ADDENDUM

NO. 3

PROJECT NAME: Lehman High School 2025 Additions and Renovations

ADDENDUM DATE: 14 May, 2025

01 FIRST FLOOR PLAN - AREA A - POWER
SCALE: 1/16" = 1'-0"

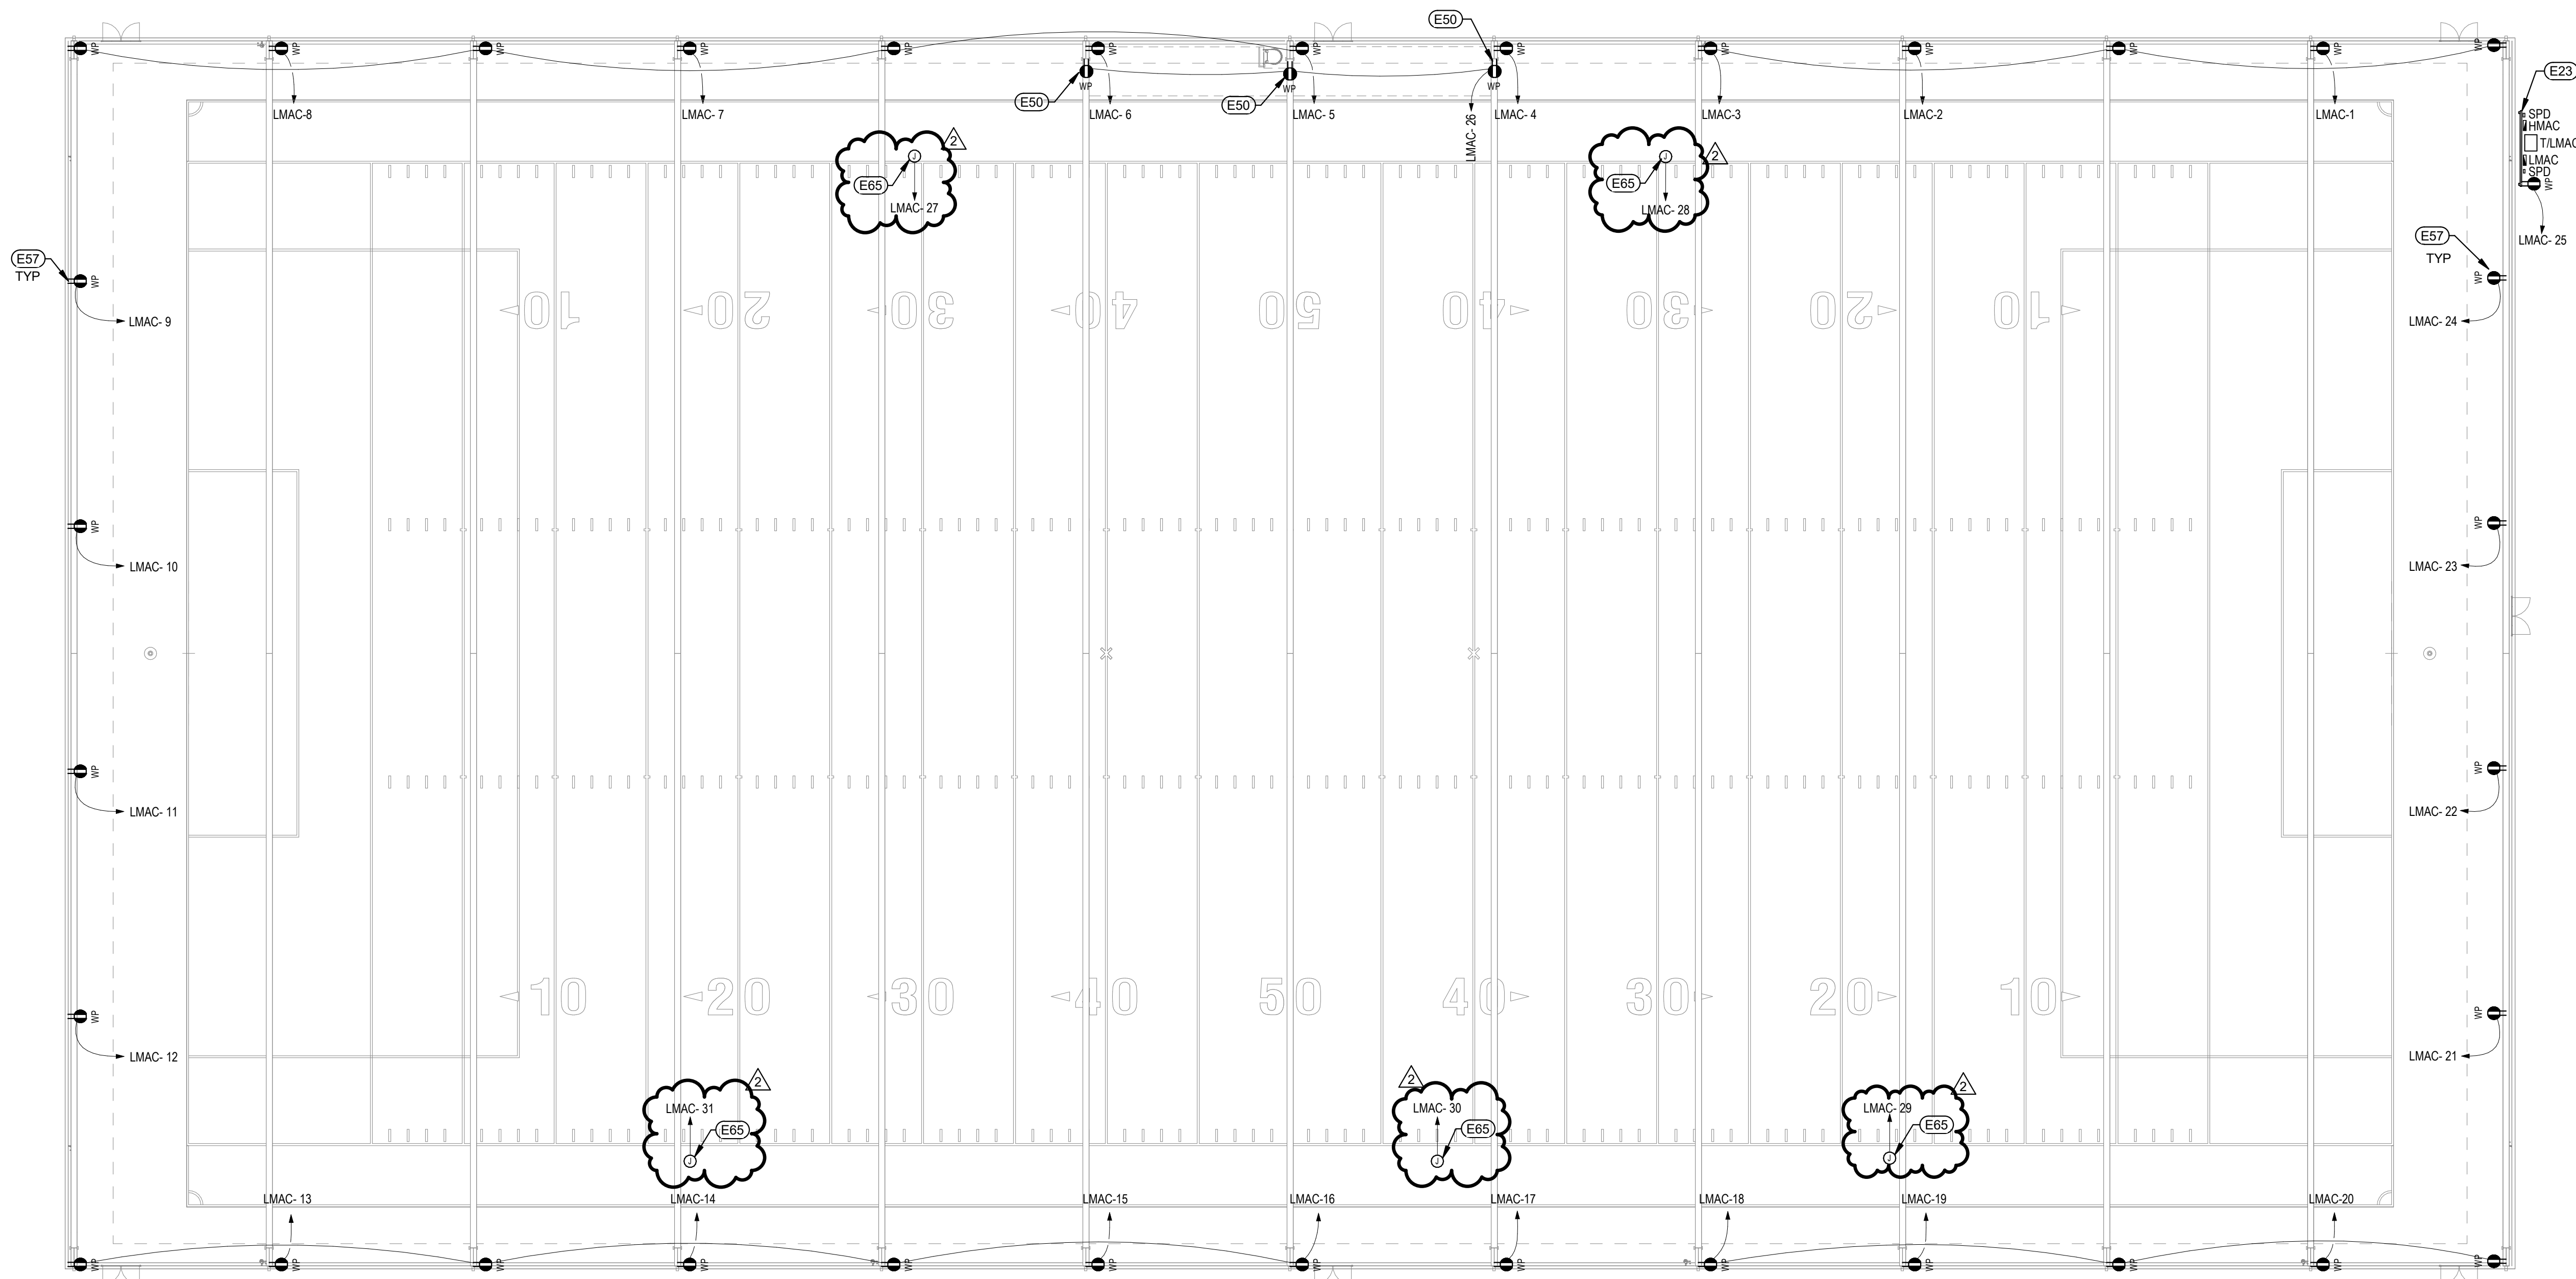
- 1) Added power for sports netting equipment.

01 FIRST FLOOR PLAN - AREA C - POWER

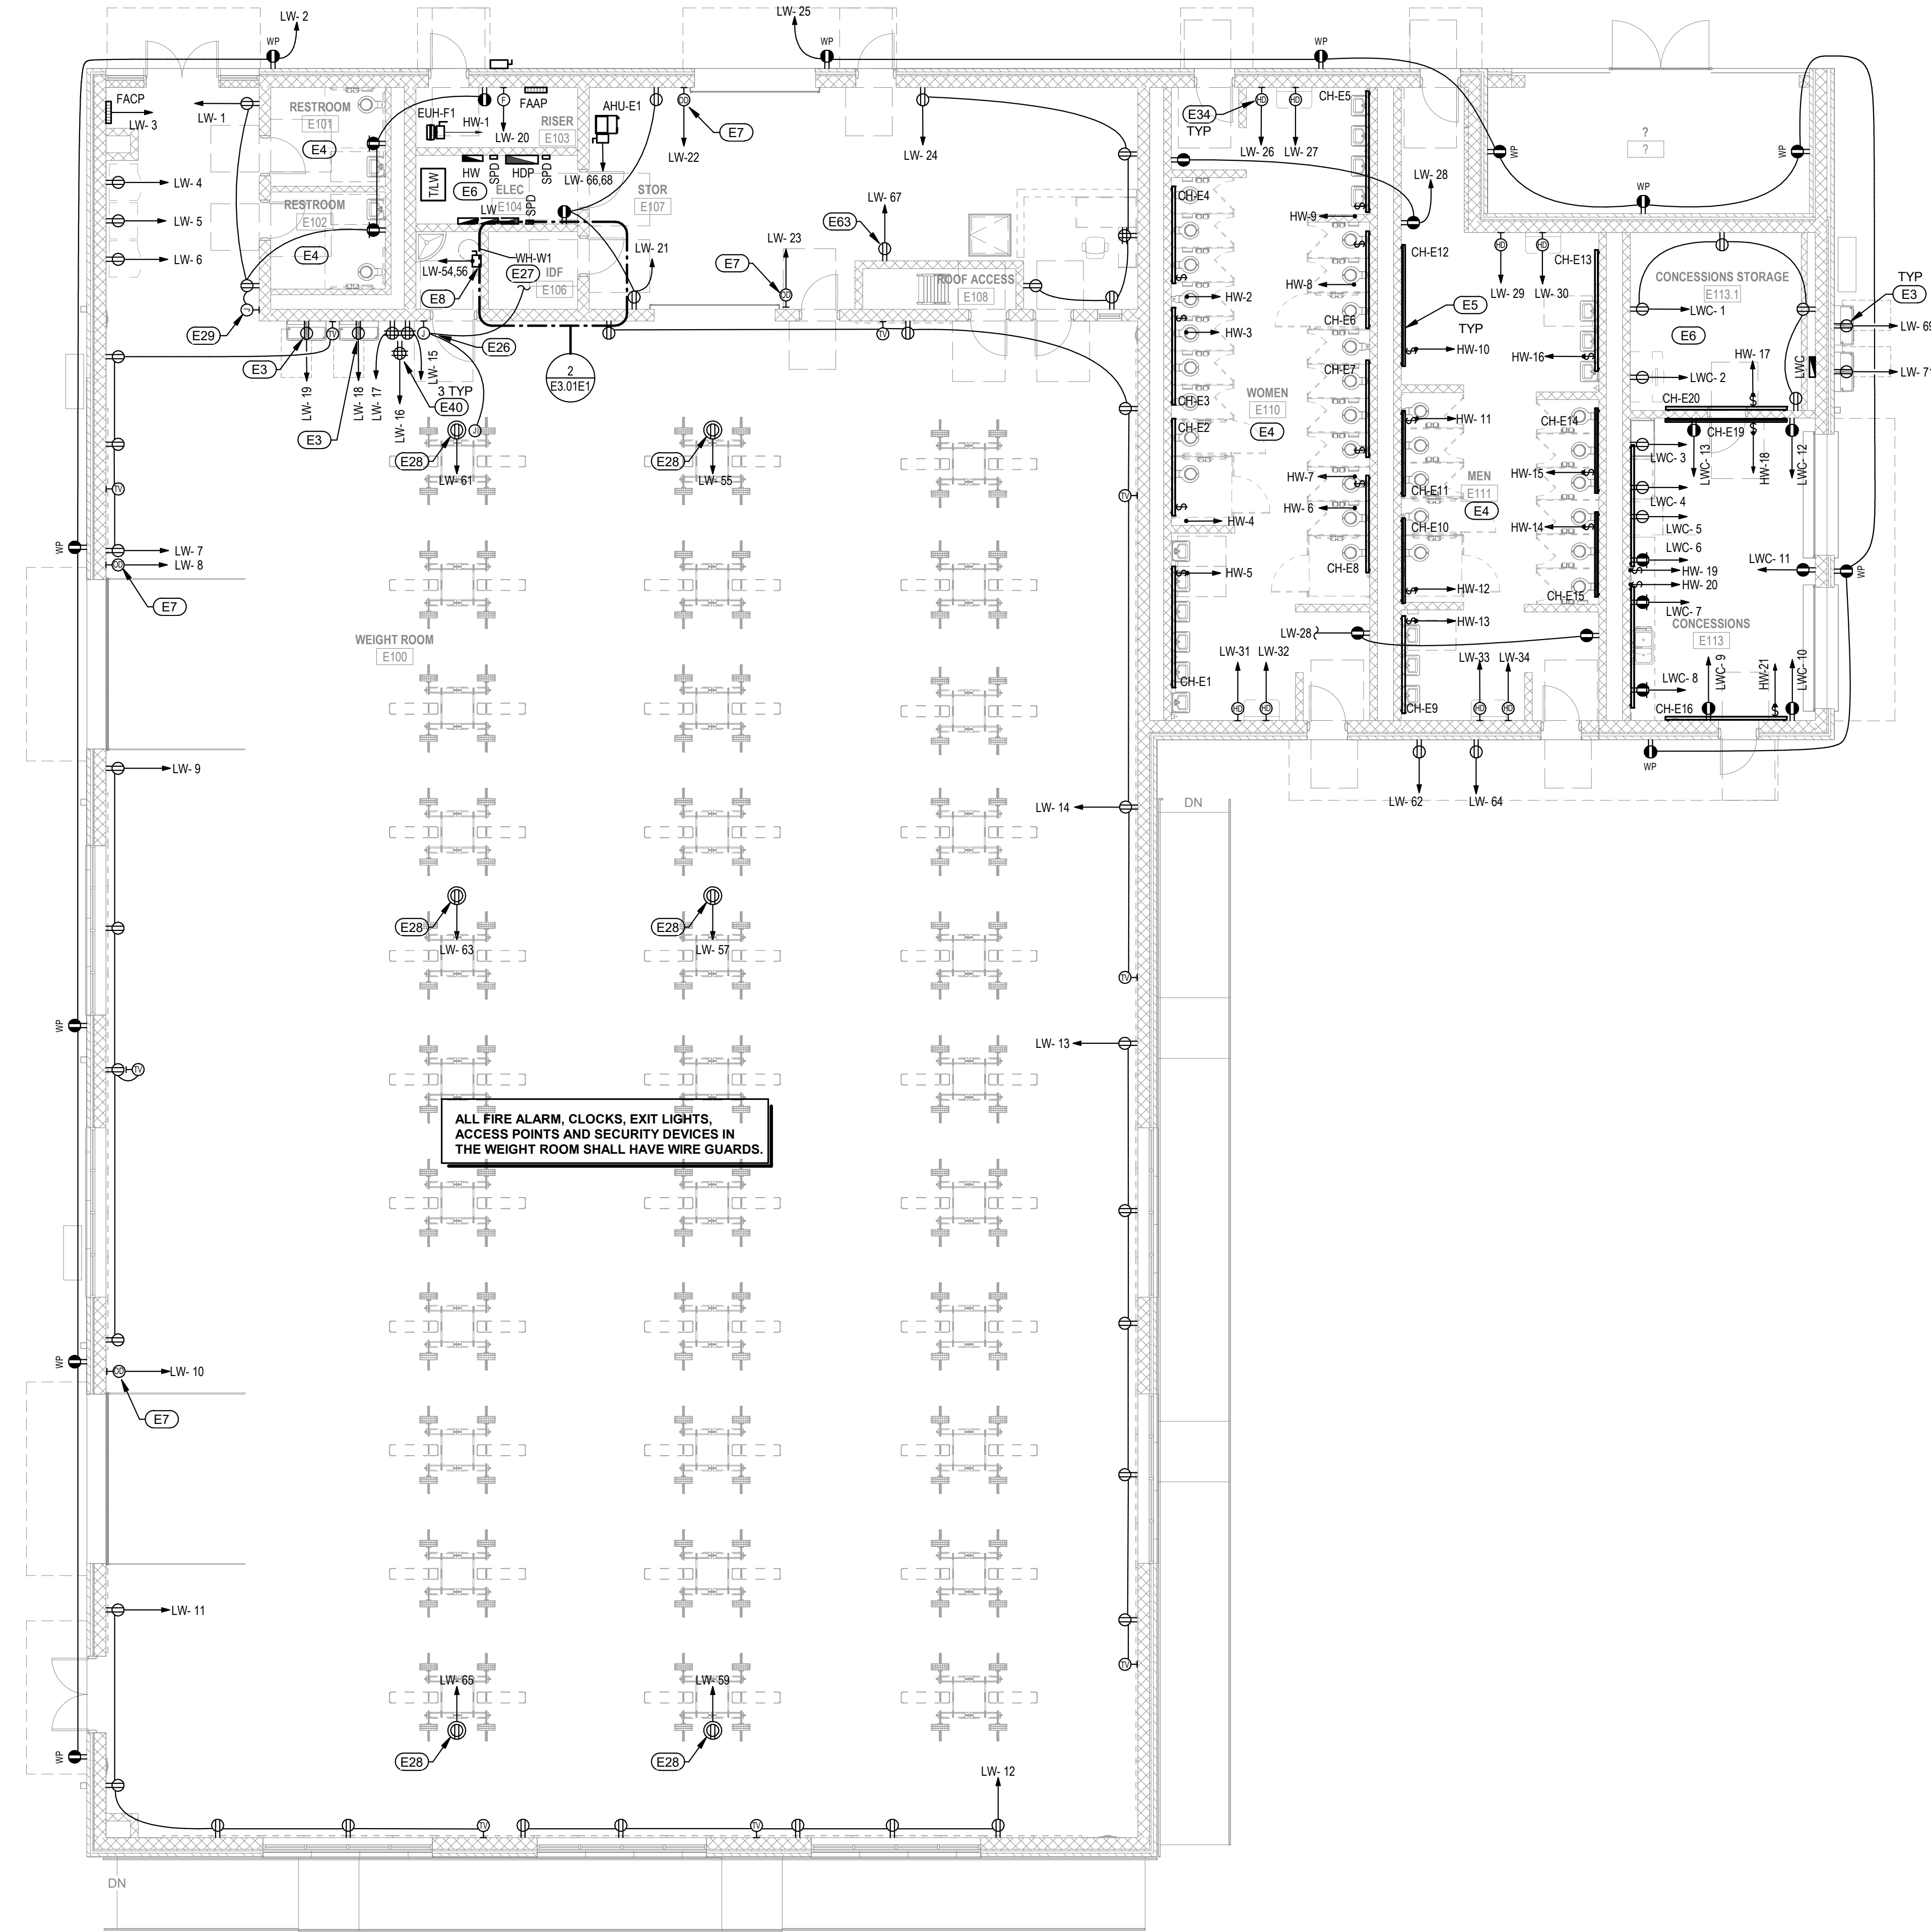
- 1) Added power for air purifiers as shown.
